CALIFORNIA INSTITUTE OF TECHNOLOGY
MASSACHUSETTS INSTITUTE OF TECHNOLOGY
 Laser Interferometer Gravitational Wave Observatory (LIGO) Project

To:	
From:	Peter Fritschel
Phone/FAX:	
Refer to:	LIGO-T030094-01-D
Date:	16 May 2003

Subject: LOS Coil Driver & Universal Dewhitening Filter revisions

Figure 1. Top: Electronics noise levels from DW-filtered DAC noise and coil driver noise on the ETMs, with the modified coil driver and DW filter. Bottom: Available acquisition current for each ETM coil with the new, modified coil driver, compared to the old (existing) design.

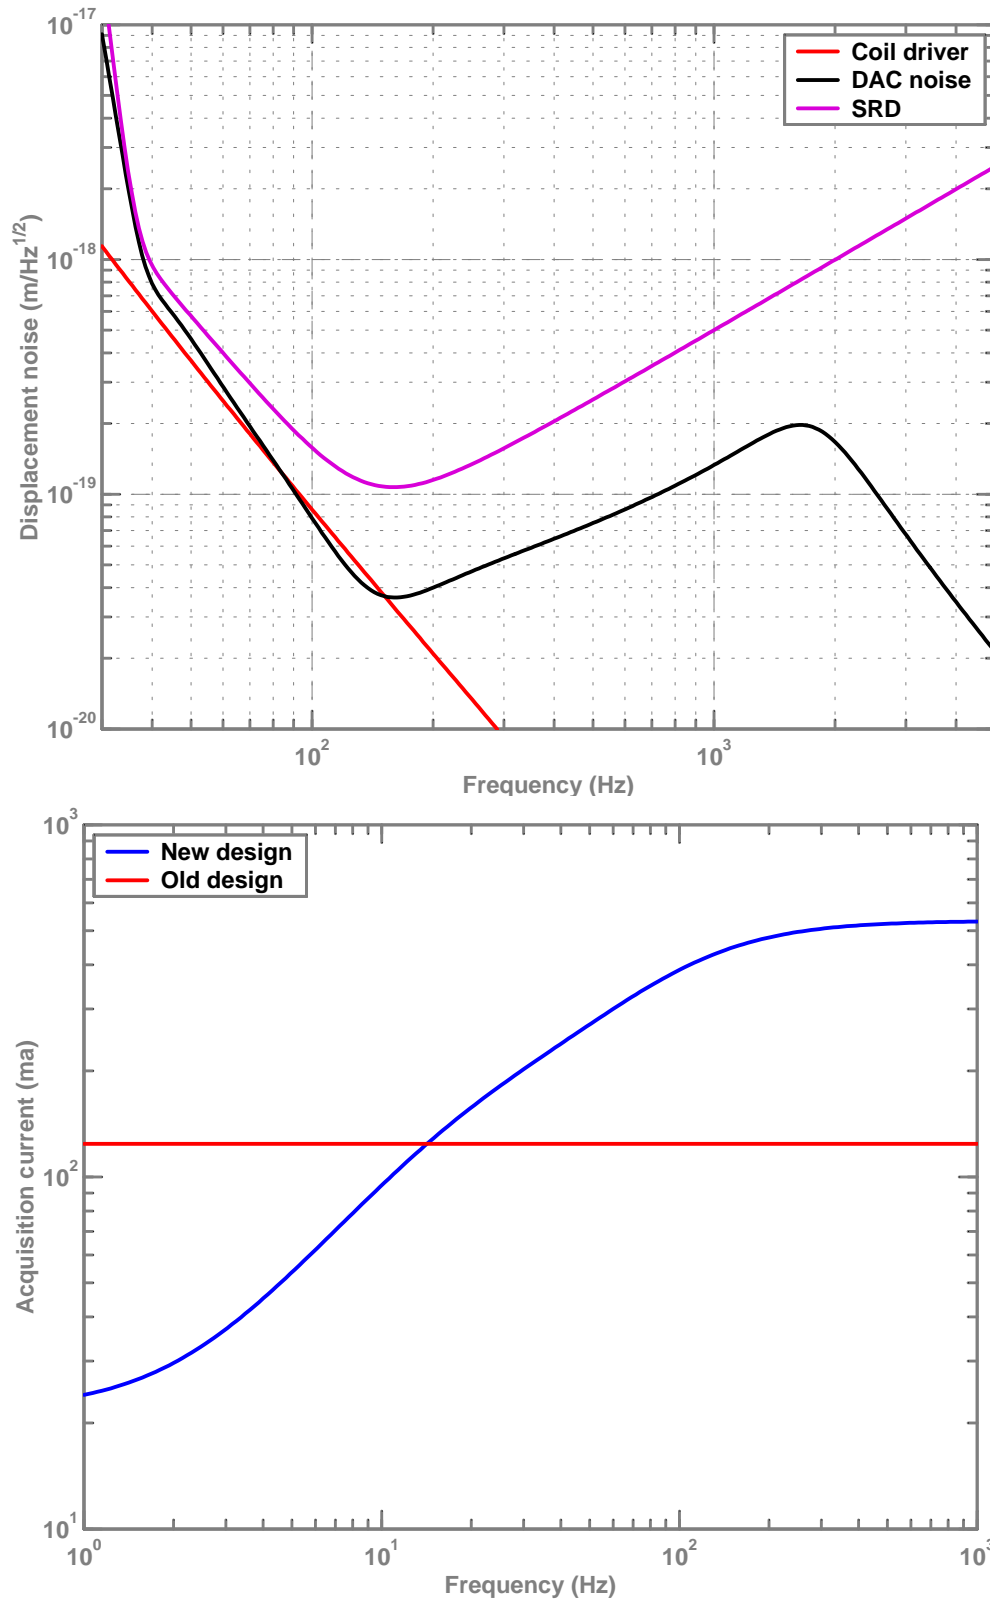
This memo details recommended revisions to the LOS coil drivers and Universal dewhitening filters currently installed at LHO. The revisions will make the coil drivers similar to the current LLO design, with a couple of differences to achieve lower noise. The major elements of the revisions are:

- > implement the RUN/ACQUIRE mode feature provided by the original design, to supply higher acquisition current and lower detection mode noise
- > reduce the voltage noise at the PA-85 output, with a combination of lower-valued resistors and some modest filtering
- > change the output op-amps in the Universal Dewhitening Filter to a higher-current part
- > modify the filtering in the Universal Dewhitening Filter to have more attenuation at high frequencies

Component	Current value	New value	Comment
Coil driver modifications (D000325)			
R126, R134, R92, R84	21.6 kohm	7.2 kohm	Purpose: reduce Johnson noise. DC gain is 12.63. DW filter op-amp output of 12.5V gives 158 V at PA-85 output. New linear supplies are only 150V, so ok.
R145, R148, R103, R101	1.6 kohm	470 ohm	
R123, R125, R82, R78	100 kohm	7.2 kohm	Purpose: provide factor of 2 voltage noise filtering above 40 Hz. Cap: suggest metallized polypropylene film cap, Panasonic part ECW-F4564JB (400WV)
C52, C55, C25, C24	5 μ F	0.56 μ F	
Cadd	–	1 nF	Put in parallel with R126, etc., to provide noise filtering at high frequency. Suggest mica cap.
R126,R127,R135,R136,R93,R94,R85,R86	10 ohm	2.8 ohm	Sets PA-85 current limit to approx. 484 ma. Two 2.8 ohm in parallel, or equiv. to give 1.4 ohm.
R132, R140, R89, R91	1.0 kohm	7.2 kohm	In detect mode, allows 20 ma-pk coil current.
R143, R144, R100, R102	160 ohm, 1 W	150 ohm, 25 W	Use Dale RH-25 25W, 1%, or higher wattage rating if desired; mount them to the PA-85 heatsinks. Tap the resistor solder lugs for 4-40 allen screws; attach wire crimp-on lugs for easier removal when board access req'd

F1, F2, F3, F4	?	200-250 mA medium-blow	LLO currently uses 250 ma fuses, GMC250 medium time delay, 5mmx20mm
R75	7.18 kohm	1.0 kohm	Allows more coil current to side coil, to avoid saturation behavior.
U11	LT1028	TLE2027	
C36,C46,C35,C44,C62,C71,C63,C75	2.2 μ F, electrolytic	2.2 μ F, poly, 250 V, Panasonic ECQ-E	Use Panasonic ECQ-E series, add a .1 μ F ceramic in parallel
New: Diode transient suppression		1.5KE200A	Add Zener diode transient suppressors from PA-85 power supplies to ground; see Apex application note 25 (Fig. 10)
New: Fast rectifiers for fly-back protection		UF1007	Add rectifiers from PA-85 output to power supplies; see Apex application note 25 (Fig. 10)

Component	Current value	New value	Comment
Dewhitening filter modifications			
U30, U23, U10, U2	AD797	LT1128	AD797's are susceptible to becoming noisy
C32, C3, C89, C108	1.0 μ F	0.18 μ F	Move real zero from 98 Hz to 393 Hz; pole changes slightly, 1223 Hz to 1180 Hz
R50, R6, R123, R164	130 ohm	750 ohm	
A1 upgrade board (D010047), U1	LT1125	TLE2027	New upgrade board required for TLE, single op-amp package; TLE required for needed output current
B version: Ub1,Ub2,Ub3,Ub4	AD829	TLE2027	AD829 not happy in follower configuration; TLE is stable and low-noise, 2.5 nV/rtHz
